Strategic Housing Development Large Scale Residential Development at Hartfield Place, Swords Road, Whitehall, Dublin 9

Response to ABP Opinion and DCC comments on Pre
Application Consultations

Eastwise Construction Swords Limited.

March 2022

Figure 2.9 Bicycle Ramp Basement Layout (Source: C+W O'Brien Architects Drawing No. 092035)

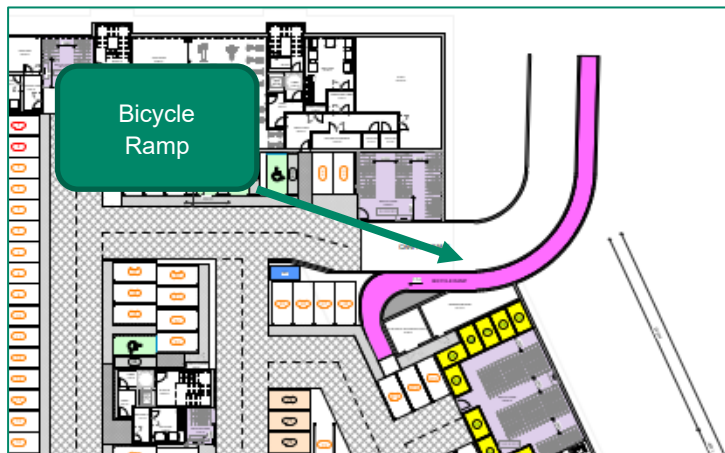
If it is proposed that cyclists share the basement ramp access with motor vehicles, the access ramp should include a separate lane clearly marked for the use of cyclists and be of sufficient width (e.g. 1.8m wide). In all cases, accesses to parking within a building should be well lit and motorists warned of the likely presence of cyclists by means of suitable warning signs and markings. Also consider the gradient and surface material of the access ramp for cyclists. A clearance headroom of minimum 2.4m should be provided wherever cyclists can be expected to be cycling their bikes.

A segregated ramp for cyclists providing a separate lane (2.0m) for cyclists is now included on the architects plans (C+W O'Brien Drawing-092035) and illustrated in Figure 2.9

The basement parking facility will be well lit and signed appropriately for cyclists with headroom sufficient for cyclists (2.4m). Gradient of the ramp is 1:14 and a non-slip wear overlay will be applied to the top surface of the ramp.

Figure 2.10 Motorcycle Spaces Basement Layout (Source: C+W O'Brien Architects Drawing No. 092035)

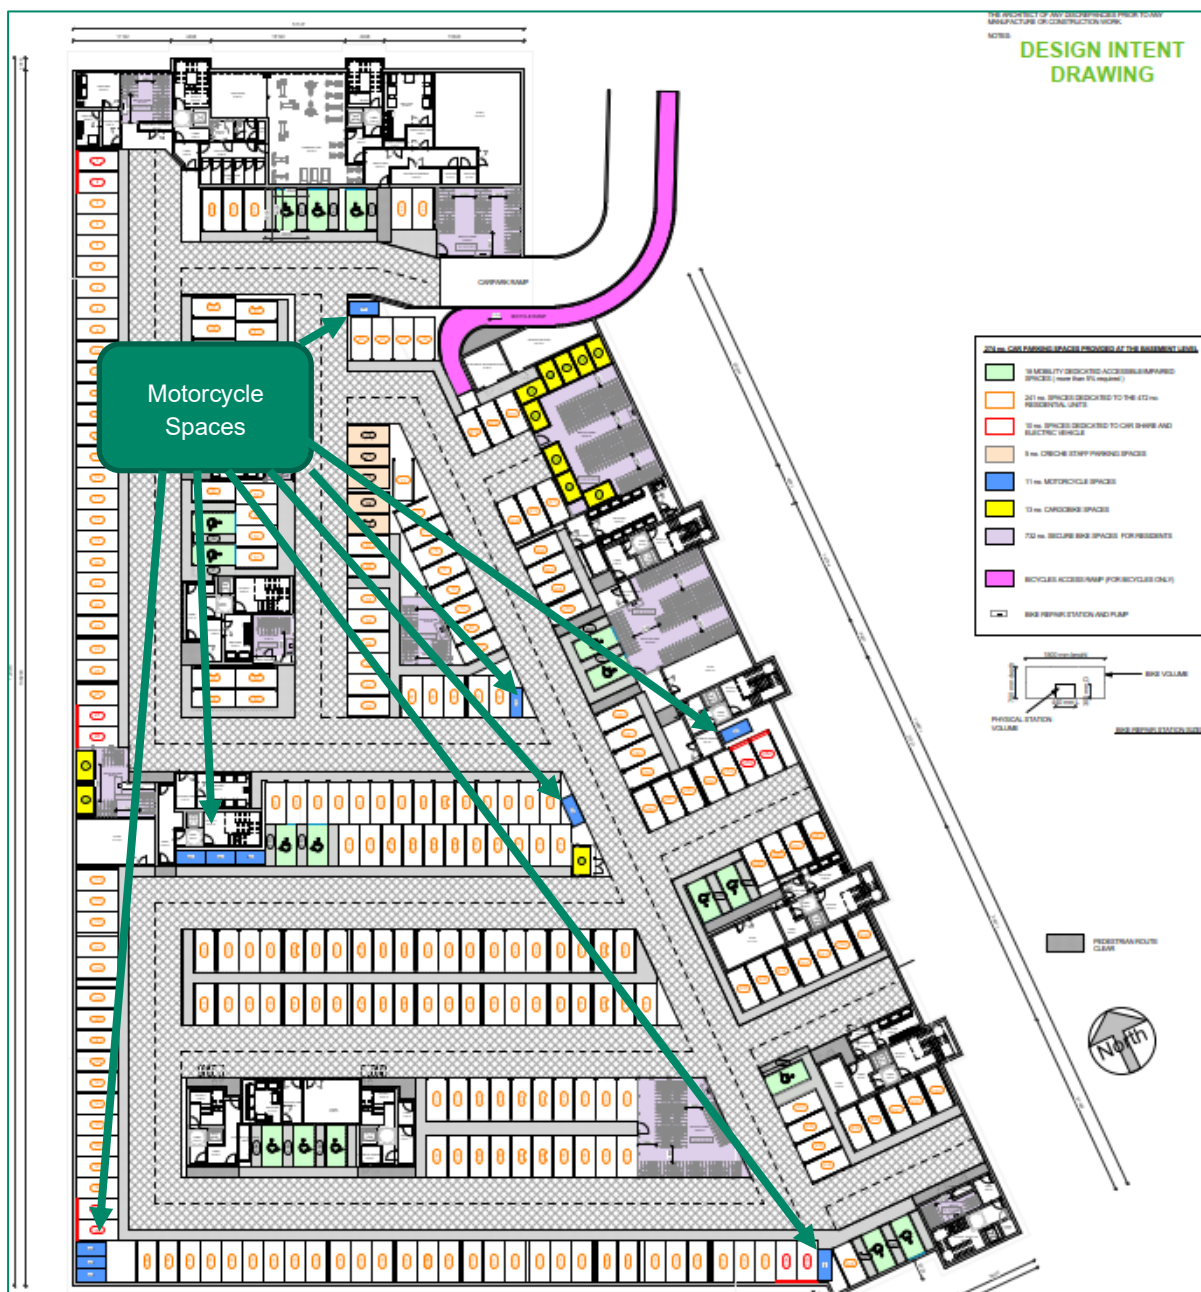
The provision of motorcycle spaces is below the Development Plan requirements. The applicant is requested to review motorcycle parking allocation ensure that designated motorcycle parking areas do not impede access to cycle parking stores and that all spaces are numbered.

14 No. motorcycling spaces have been allocated around the basement parking facility, representing circa 4% of parking as stated in the DCC Development Plan. All motorcycle parking does not impede cycle parking storage as per the basement plan. See architects basement plan (C+W O'Brien Drawing no. 092035) and Figure 2.10 below.

Figure 2.11 Taken in Charge drawing (AECOM drawing no. PR379360-ACM-XX-XX-DR-CE-20-0003)

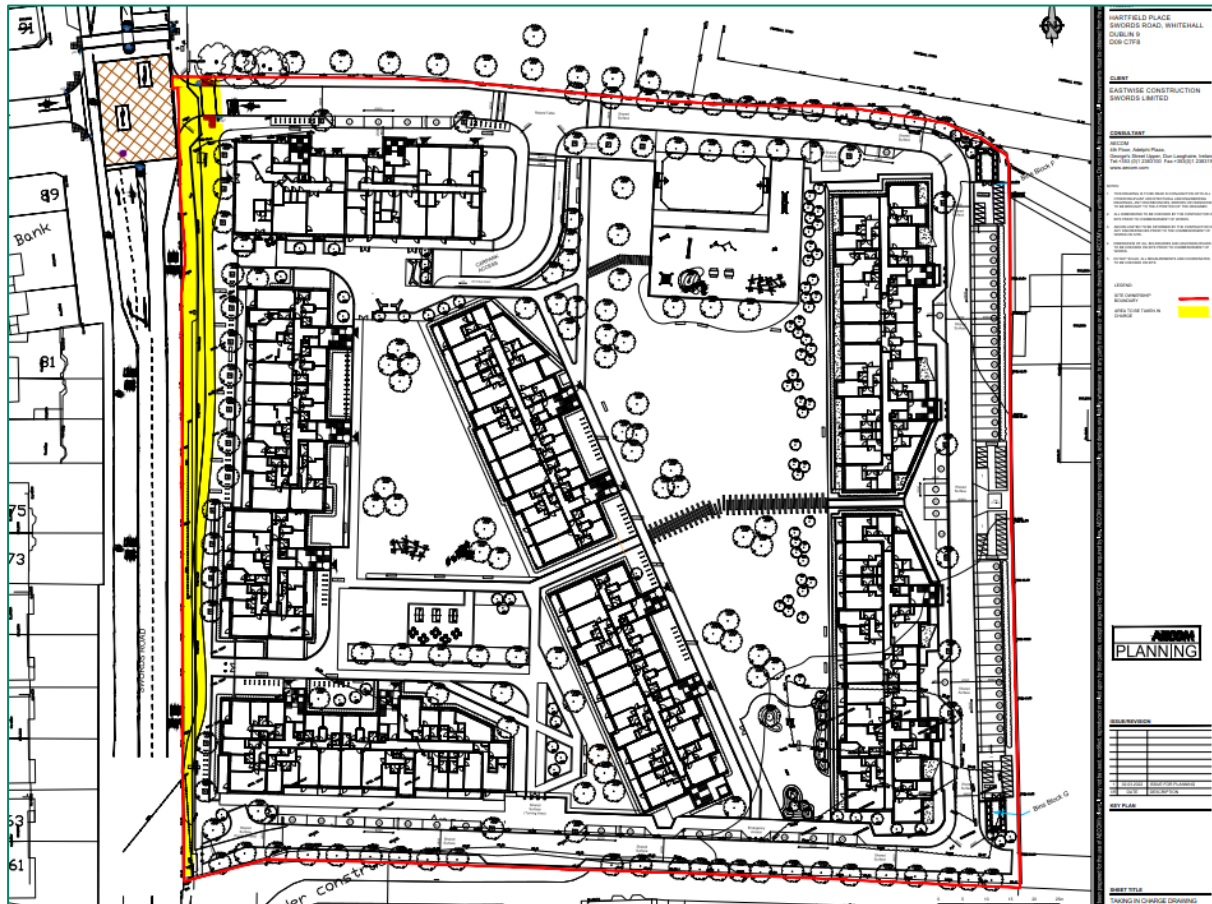
15. Submit a Construction Management Plan.
16. The applicant is requested to outline any lands for Taking in Charge by Dublin City Council.

The Taken in Charge lands are shown in AECOM Drawing PR379360-ACM-XX-XX-DR-CE-20-0003 and below in Figure 2.11
